Access Compliance Report

Public Rights-of-Way

(Curb Ramps)

Intersection ID: 47270	Main Street: MARVILLE_CT	Cross Street: SAVANNAH_HILLS_DR	Location: NE
ADA ID: 08876D03916A	Ramp Type: Perp	Initial Pass/Fail: Fail	Overall Compliance: No
Codes/Mitigation Info/Possible Solution		Field Measurements/Component Compliance	
Severity Score: 10

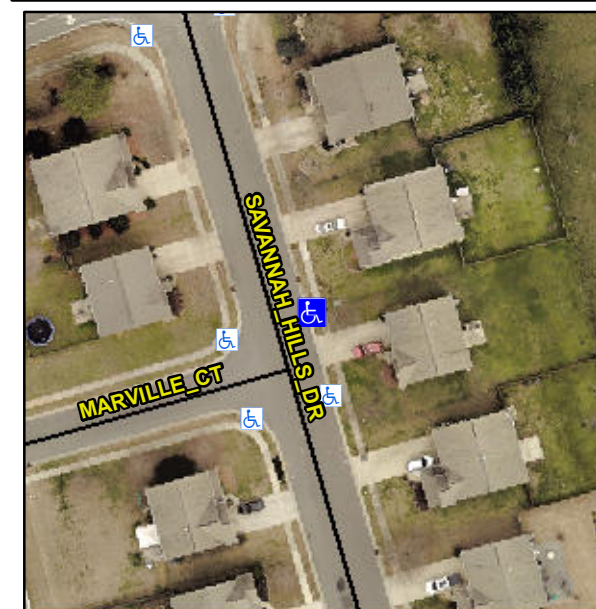
Not Found, R304.5.1

Compliance	Description	Data	Compliance	Description	Data
N/A	Ramp Length (in)	46.0	Yes	Ramp Slope (%)	6.5
No	Ramp Width (in)	38.0	Yes	Ramp XSlope (%)	3.7
N/A	Flare Type LT	N/A	N/A	Flare Type RT	N/A
N/A	Flare Slope LT (%)	N/A	N/A	Flare Slope RT (%)	N/A
N/A	Flare Traversable LT?	N/A	N/A	Flare Traversable RT?	N/A
N/A	Landing Length (in)	N/A	N/A	DWS Provided?	N/A
N/A	Landing Width (in)	N/A	N/A	DWS Contrast?	N/A
N/A	Landing Slope (%)	N/A	N/A	DWS Length (in)	N/A
N/A	Landing X Slope (%)	N/A	N/A	DWS Full Width?	N/A
N/A	Landing Curb? (Y/N)	N/A	N/A	DWS Offset (in)	N/A
N/A	Shared Landing?	N/A			
N/A	Gutter Ponding?	N/A	N/A	Gutter Slope (%)	N/A
N/A	Gutter Lip Ht (in)	N/A	N/A	Gutter X Slope (%)	N/A
N/A	Painted X Walk1?	No	N/A	Painted X Walk2?	N/A
	X Walk 1 Direction	To W		X Walk 2 Direction	N/A
N/A	X Walk 1 Width (in)	N/A	N/A	X Walk 2 Width (in)	N/A
	X Walk 1 Slope (%)	6.5		X Walk 2 Slope (%)	N/A
	X Walk 1 X Slope (%)	4.1		X Walk 2 X Slope (%)	N/A

Remove & Replace Entire Ramp.
